Mr. William O. Parker, Jr.
Vice President - Steam Production
Duke Power Company
P. O. Box 2178
422 South Church Street
Charlotte, North Carolina 28242

The Commission has issued the enclosed Amendments Nos. 83, 83, and 80 for Licenses Nos. DPR-38, DPR-47 and DPR-55 for the Oconee Nuclear Station, Units Nos. 1, 2 and 3. These amendments consist of changes to the operating licenses and the Station's common Technical Specifications in response to your request dated September 22, 1976, as supplemented September 11, 1979, and your request dated November 16, 1979, as superseded March 12, 1980 and supplemented April 30, 1980.

These amendments revise the Technical Specifications to support the operation of Oconee Unit No. 2 at full rated power during Cycle 5. The amendments also incorporate monitoring conditions for secondary water chemistry in the body of the licenses for Units Nos. 1, 2 and 3 in response to your request dated September 11, 1979, and staff discussions.

ATTACHMENTS TO LICENSE AMENDMENTS

CORE PROTECTION
SAFETY LIMITS
UNIT 2
OCONEE NUCLEAR STATION
Figure 2.1-2B

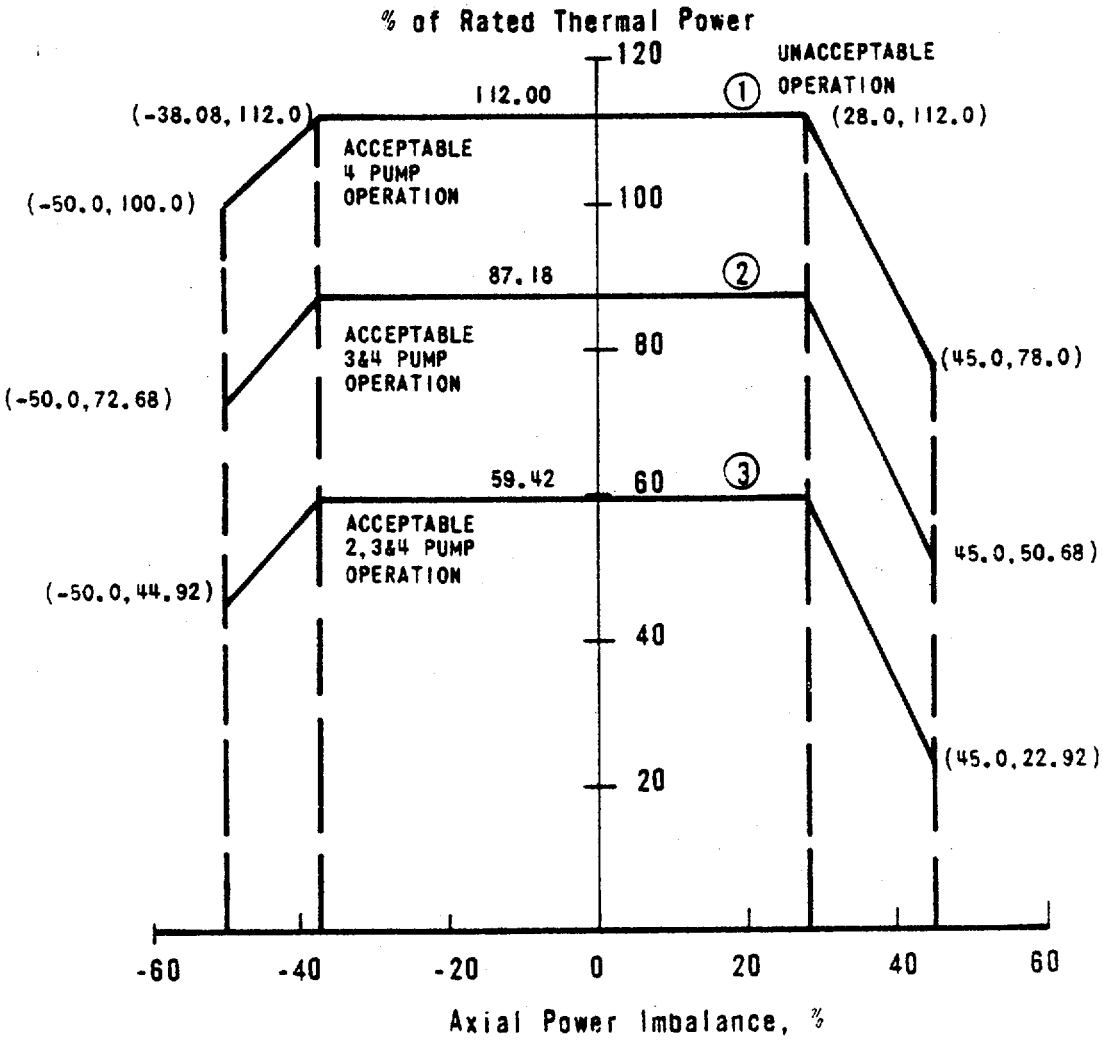
The specified flow rates for Curves 1, 2, and 3 of Figure 2.1-2B correspond to the expected minimum flow rates with four pumps, three pumps, and one pump in each loop, respectively.

The curve of Figure 2.1-1B is the most restrictive of all possible reactor coolant pump-maximum thermal power combinations shown in Figure 2.1-3B.

PROTECTIVE SYSTEM
MAXIMUM ALLOWABLE SETPOINTS
UNIT 2
OCONEE NUCLEAR STATION
Figure 2.3.2B

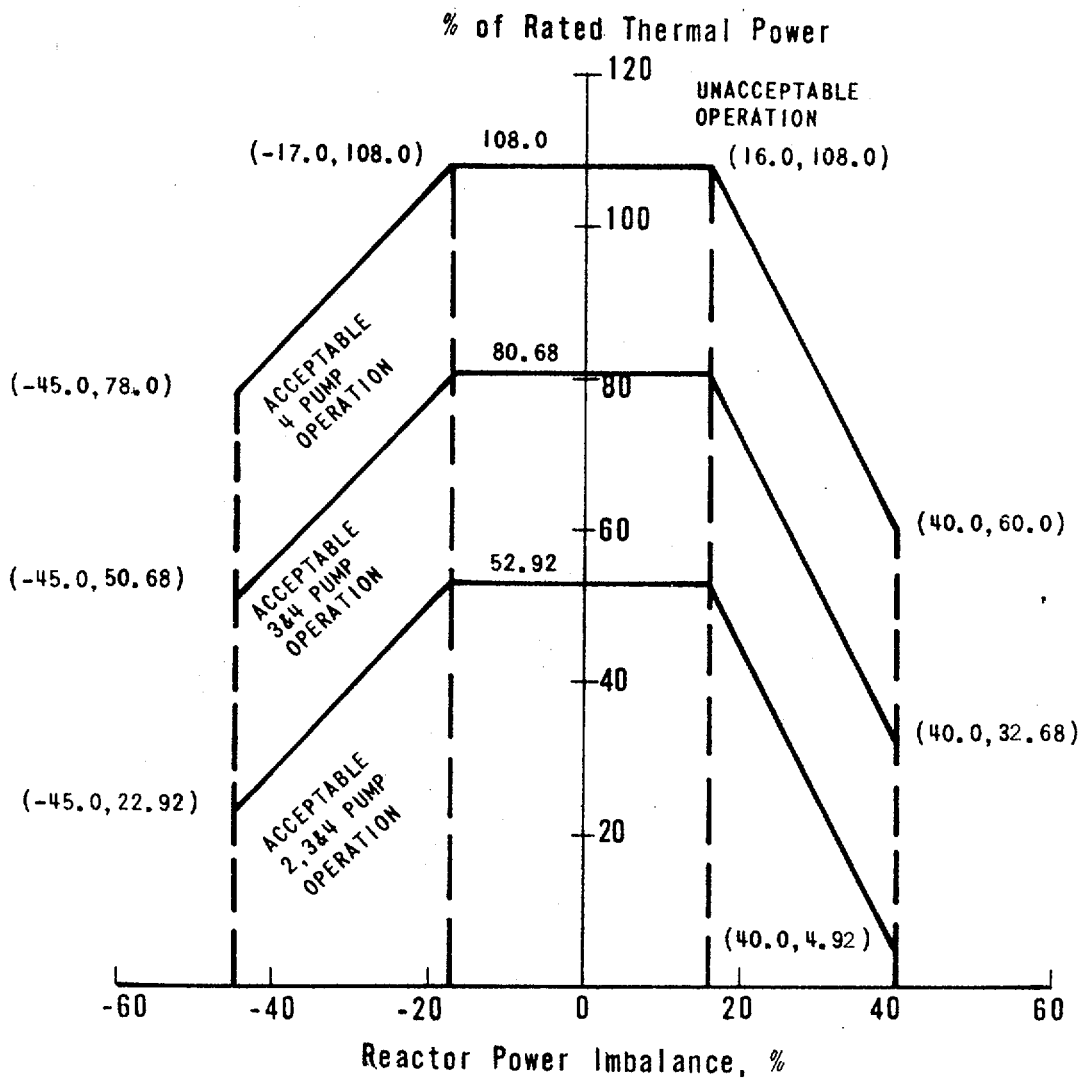
During a startup accident from low power or a slow rod withdrawal from high power, the system high pressure setpoint is reached before the nuclear over-power trip setpoint. The trip setting limit shown in Figure 2.3-1A - Unit 1
2.3-1B - Unit 2
2.3-1C - Unit 3
for high reactor coolant system pressure (2355 psig) has been established to maintain the system pressure below the safety limit (2750 psig) for any design transient. (1)

The low pressure (1800) psig and variable low pressure (11.14 T_{out}-4706) trip
(1800) psig (11.14 T_{out}-4706)
(1800) psig (11.14 T_{out}-4706)
setpoints shown in Figure 2.3-1A have been established to maintain the DNB
2.3-1B
2.3-1C
ratio greater than or equal to 1.3 for those design accidents that result in a pressure reduction. (2,3)

The high reactor coolant outlet temperature trip setting limit (619°F) shown in Figure 2.3-1A has been established to prevent excessive core coolant
2.3-1B
2.3-1C
temperatures in the operating range. Due to calibration and instrumentation errors, the safety analysis used a trip setpoint of 620°F.
